**SUBJECT:** COMANCHE PEAK NUCLEAR POWER PLANT, UNITS 3 AND 4  
DOCKET NUMBERS 52-034 AND 52-035  
RESPONSE TO REQUEST FOR ADDITIONAL INFORMATION NO. 3006

Attachment: Response to Request for Additional Information No. 3006 (CP RAI #122)

**Response to Request for Additional Information No. 3688 (CP RAI #92)**

**Tunnel Segment 1 SASSI Explicitly Modeled Soil Elements**

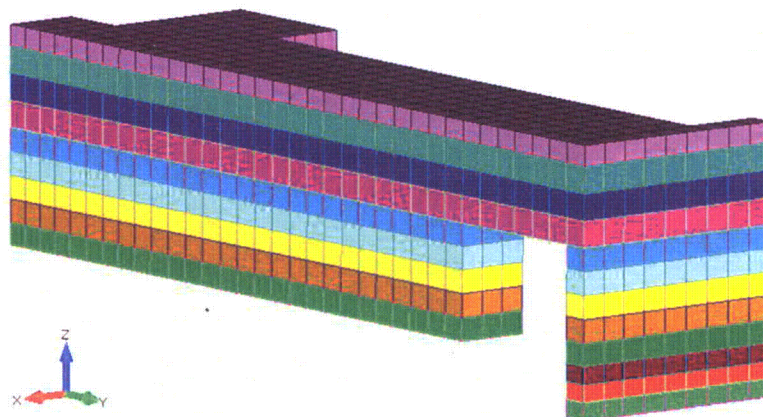
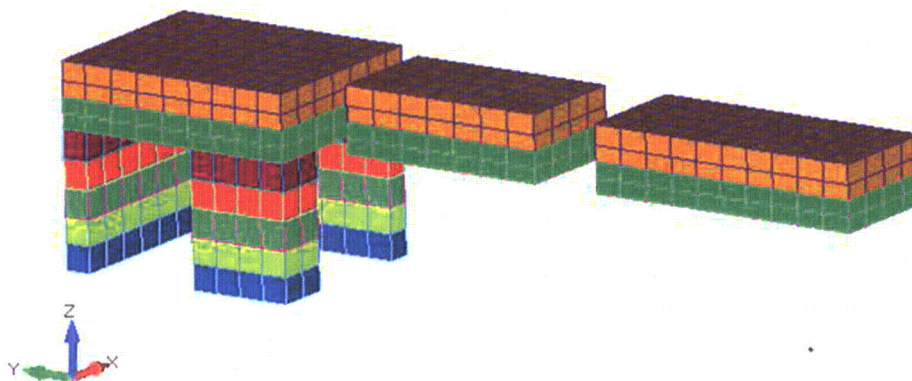
(a) Provide a description, including figures, that shows how the surrounding soil was modeled in the SASSI SSI analysis. What are the assumed boundary conditions? Address the location where the input motions were applied to the model. Were the input motions in time domain or in the form of response spectra? What is the damping ratio assumed for the input motions?

The input motions are applied to the model at the top of the limestone (bottom of backfill) at the far-field, effectively meaning at a sufficient distance from the structure to not be influenced by soil structure interaction effects. Input motions are applied as time history accelerations (time domain) with a time step of 0.005 seconds. The damping for the model is not input as part of the time history accelerations but rather as material damping within the soil layer model and structural materials. The concrete materials were assigned 4% material damping in accordance with RG 1.61 Table 2 for use in generation of in-structure response spectra.

**Figure 3MM-2 Maximum Seismic Base Shear Forces in Wall**

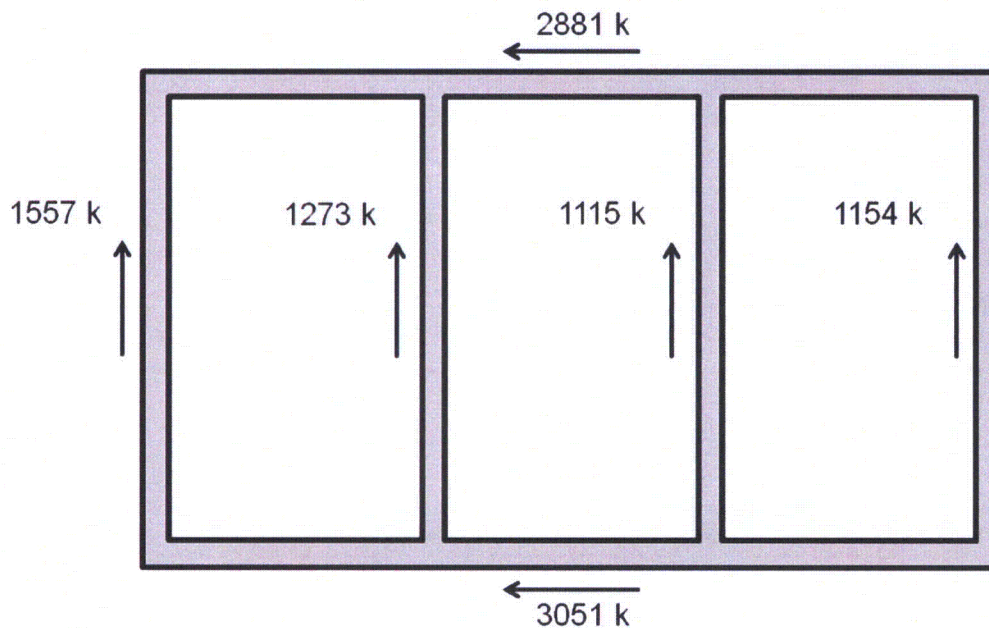
CP COL 3.8(29) in CPNPP COL FSAR inserts subsection 3.8.4.4.3.3, "PSFSVs", which references Appendix 3MM. In Appendix 3MM, "Model Properties and Seismic Analysis Results for PSFSVs," Section 3MM.3, "Seismic Analysis Results," the second paragraph (Page 3MM-3) states that "The total adjusted wall shear forces used for design are presented in Figure 3MM-2."

The applicant is requested to explain why these shear forces presented in Figure 3MM-2 are not symmetric? Seismic may come in any direction. Provide a rationale for not using symmetric forces in the design.

FSAR Figure 3.8-201 shows the general layout of the east and west PSFSVs. FSAR Figure 3MM-2 shows seismic shear forces for the west PSFSV. The forces presented in the figure are not symmetric because the soil and structure system is not symmetric. Soil exists only on two sides of the west PSFSV (south and west sides of the west PSFSV) with seismic isolation joints existing on the other two sides to separate the PSFSV from adjacent structures. The north side and east side of the west PSFSV are each separated by an isolation joint and therefore are not connected to the free field soil. The west wall of the west PSFSV is tapered from 2.5 ft to 4.5 ft at the base to allow the structure to resist the soil load on this long span wall. All other exterior walls are 2.5 ft thick and all interior walls are 1.5 ft thick and therefore lighter. The north wall contains openings, reducing its total mass relative to the south wall. This causes the non-symmetrical load distribution shown in FSAR Figure 3MM-2 for the west PSFSV.

FSAR Section 3MM.3 and Figure 3MM-2 have been revised to incorporate this response.

Figure 1a:  $G/G_{max}$  vs. Strain (Sand Characteristic Behaviour, EPRI 1993)

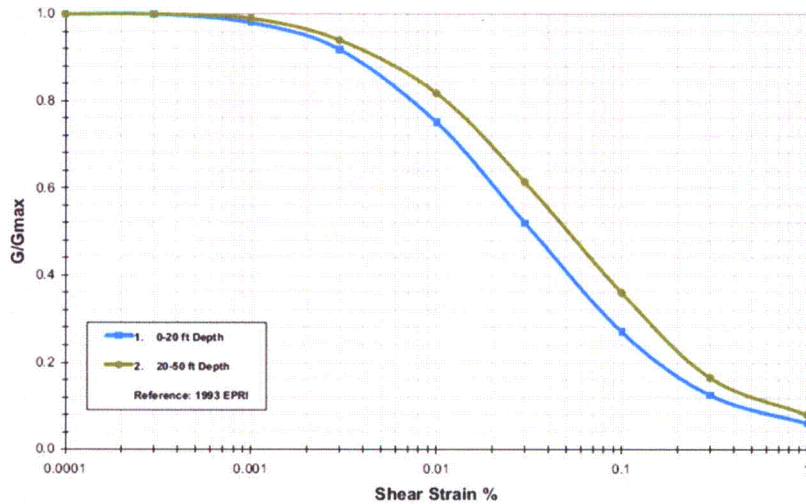
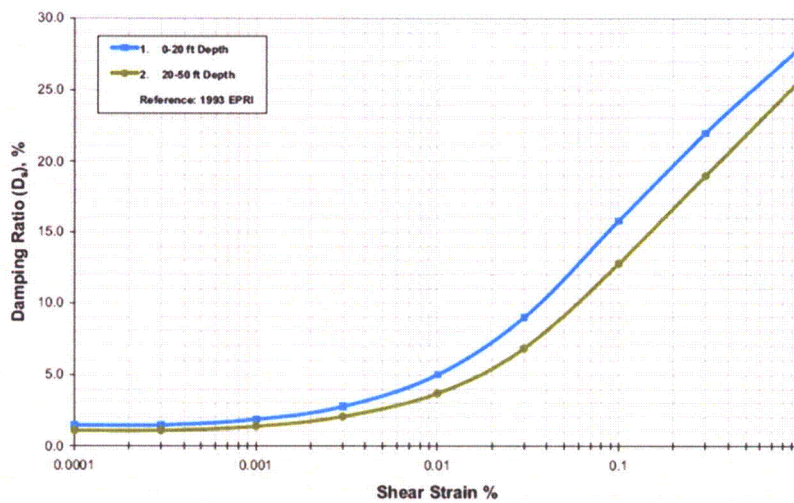
In Appendix 3NN, Section 3NN.2, "Seismological and Geotechnical Considerations," the fourth paragraph (Page 3NN-2) states that "The compression or P-wave velocity is developed for the rock and the backfill from the strain-compatible shear or S-wave velocity ( $V_s$ ) and the measured value of the Poisson's ratio. The SSI analyses use identical values for the shear S-wave and compression P-wave velocity damping. Figure 3NN-1, Figure 3NN-2 and Figure 3NN-3 present, respectively, the rock subgrade LB, BE and UB profiles for shear (S) wave velocity ( $V_s$ ), compression (P) wave velocity ( $V_p$ ) and material damping. Figure 3NN-4, Figure 3NN-5 and Figure 3NN-6 present in solid lines the results of the site response analyses for the profiles of strain-compatible backfill properties. The plots also show with dashed lines the backfill profiles that were modified to match the geometry of the mesh of the SASSI basement model. The presented input S and P wave profiles are modified using the equal arrival time averaging method."

- (a) The degradation curves presented in FSAR Figure 2.5.2-232, which are derived based on standard EPRI shear modulus reduction and damping curves for granular fill, were used to model the properties of the embedment soil, which are non-linear. The plots presenting the soil shear modulus and the damping as a function of shear strain are presented below and in FSAR Figure 2.5.2-232.
